CITY OF HAYWARD
AGENDA REPORT

SUBJECT: Preliminary Development Plan for the Cinema Place Project

CINEMA PLACE | HAYWARD, CALIFORNIA

Ground Floor Plan

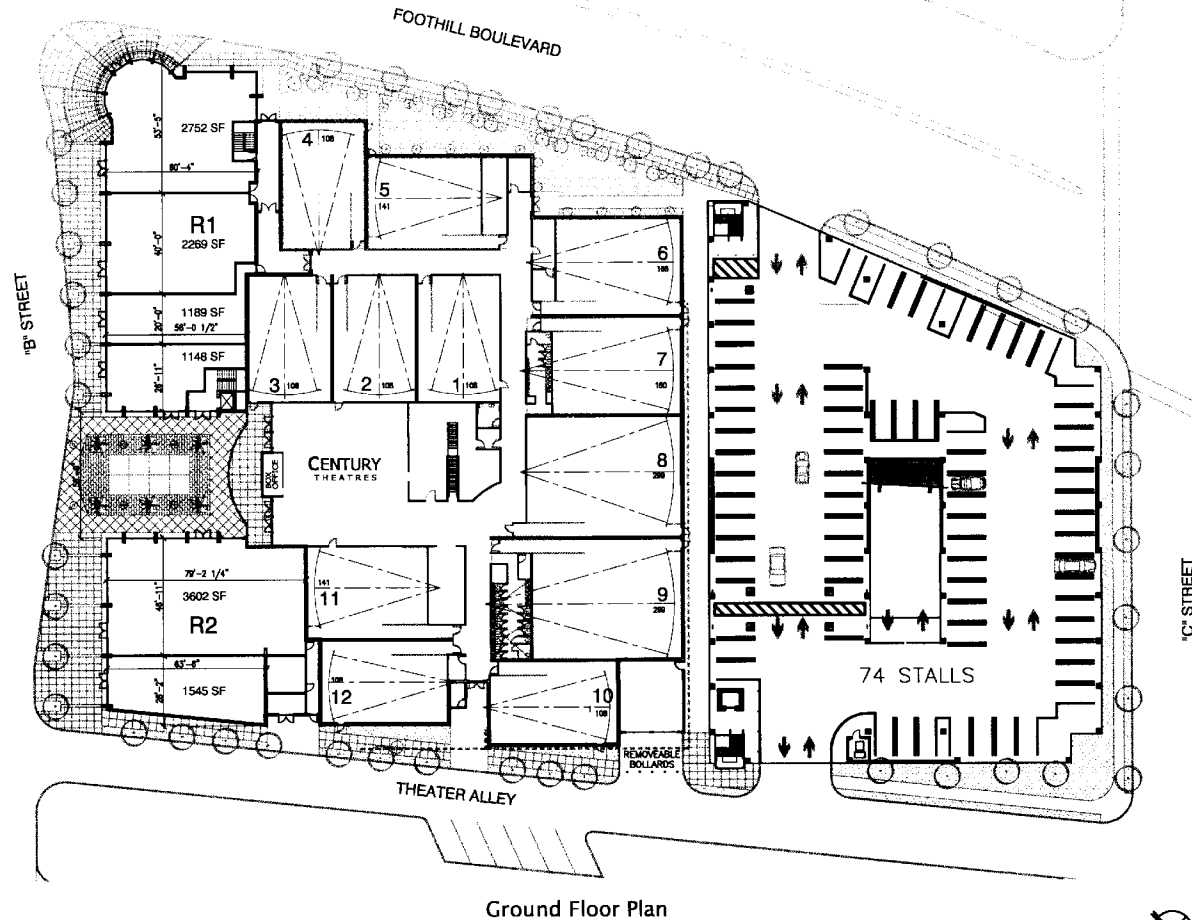
The revised plan continues to create an identity on B Street with an open linear plaza (Plan Sheet 4), lined with palm trees and decorative light fixtures on either side; the light fixtures would match those installed along B Street. The two-story entry to the theater would be at the end of the plaza. Once at the plaza, the linear landscape and lighting elements, along with the outdoor dining activity, would draw people into the space. In response to Council comments, the box office has been relocated such that it serves as a focal point of the theater entry, centered between the entry doors. The entry canopy, upon which a theater sign is affixed, would extend over 12 feet beyond the box office to provide weather protection for patrons purchasing tickets. It would be semi-circular in plan, the shape relating to the circular structure at the corner of Foothill Boulevard and B Street. The plaza is 50 feet wide, similar to the curb-to-curb width of many downtown streets, and is 50-60 feet deep,

providing ample space for meeting and congregating. The use of palm trees may not be common in this geographical setting; however, they are one of a few landscape elements that can provide a striking vertical form and evoke a connection with Hollywood and film. The applicant proposes to use stained concrete for the plaza surface with tool joints to create the patterns shown on the plans. Staff recommends that the theater plaza be strengthened visually by the use of richer, quality materials. In this regard, an alternative to poured concrete is architectural concrete pavers, which would create a more inviting appearance. These pavers can be made an integral part of the architectural design with custom colors and aggregate blending.
